# Service Bulletin

Bulletin No.: 19-NA-080

**Subject:** Information on Positive Crankcase Ventilation (PCV) Drain Tube Deletion

5314689

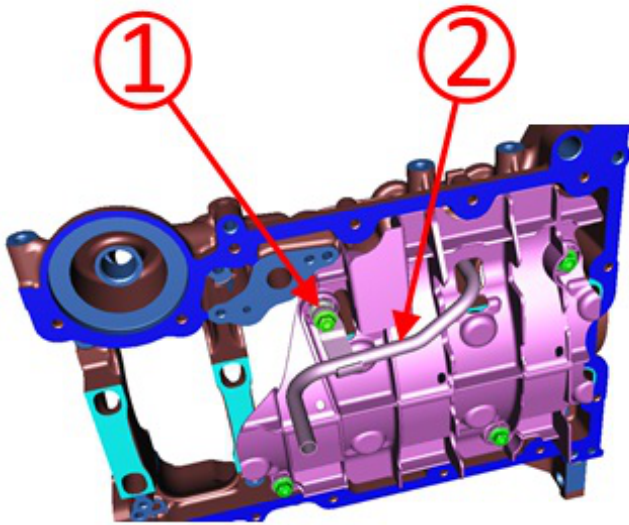
<b>Involved Region or Country</b>	North America and N.A. Export Regions
<b>Condition</b>	Some technicians may find the PCV drain tube installed during an engine repair. ⇒ General Motors has determined that the PCV drain tube is not needed and it will be deleted mid-year 2019 and forward. Please be advised you will no longer see this tube when doing an engine service on these engines.
<b>Information</b>	If the PCV drain tube on any SGE engine needs to be replaced, the tube is no longer available and replacement of the tube is no longer required. ⇒ Discard the old tube and replace the drain tube bolt with a shorter bolt to retain the crankcase oil deflector.

1. Remove the bolt (1) that secures the PCV drain tube (2) to the crankshaft deflector and bedplate.

2. Using care, remove the PCV drain tube assembly from the bedplate and discard.
3. Install the new shorter bolt.

**Note:** It is very important that you use the shorter bolt if you discard the PCV drain tube.

Tighten the bolt to 15 N•m (11 lb ft).
